Work Order ID 158767***158767***

Item Name: Basket Hoop

DESIGN #	DRAWN BY CP	DART AEROSPACE LTD HAWKESBURY, ONTARIO, CANADA	
CHECKED #	APPROVED #	DRAWING NO. D3166	REV. A SHEET 1 OF 1
DATE 02.07.10		TITLE BASKET HOOP	SCALE NTS
A	02.07.10	NEW ISSUE	
A1	04.04.08	38+/-1 WAS 36.0

DRAWING NO.	D3166	TITLE	BASKET HOOP	REV A1	DART AEROSPACE LTD ENGINEERING ORDER		D.E.O. NO.	D3166-A-2	SHEET NO.	1 OF 1	SCALE	NTS
DRAWN	AJS	CHECKED		MFG. APPR.	APPROVED	DE APPR.						
DATE	08.12.11	DATE	08.12.15	DATE	08/12/15	DATE	08/12/16	DATE	08.12.16

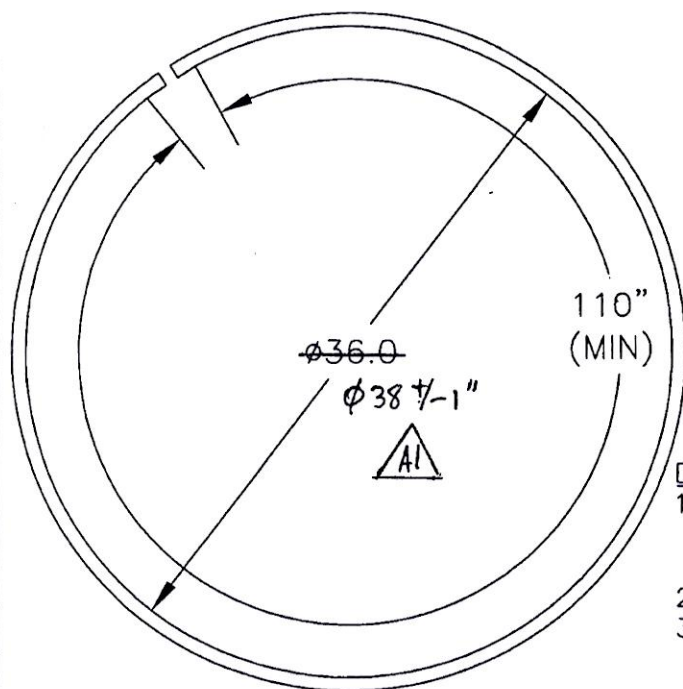
1) MODIFY MATERIAL NOTE FOR D3166-1 AS SHOWN:

IS:

1) MATERIAL: AISI 304/316 SS, 3/4 X 3/4 X 0.065 WALL SQUARE TUBING,
60.00" LONG
REF. DART SPEC M304TS0.750W.065

WAS:

1) MATERIAL: AISI 304/316 SS SQUARE TUBING,
0.75" X 0.75" X 0.063 WALL, 60.00" LONG
(REF DART SPEC. M304TS0.750W.063)

2) MODIFY MATERIAL NOTE FOR D3166-3 AS SHOWN:

IS:

1) MATERIAL: AISI 304/316 SS, 3/4 X 3/4 X 0.065 WALL SQUARE TUBING,
120.00" LONG
REF. DART SPEC M304TS0.750W.065

WAS:

1) MATERIAL: AISI 304/316 SS SQUARE TUBING,
0.75" X 0.75" X 0.063 WALL, 120.00" LONG
(REF DART SPEC. M304TS0.750W.063)

REASON: SEE PAR 08-005
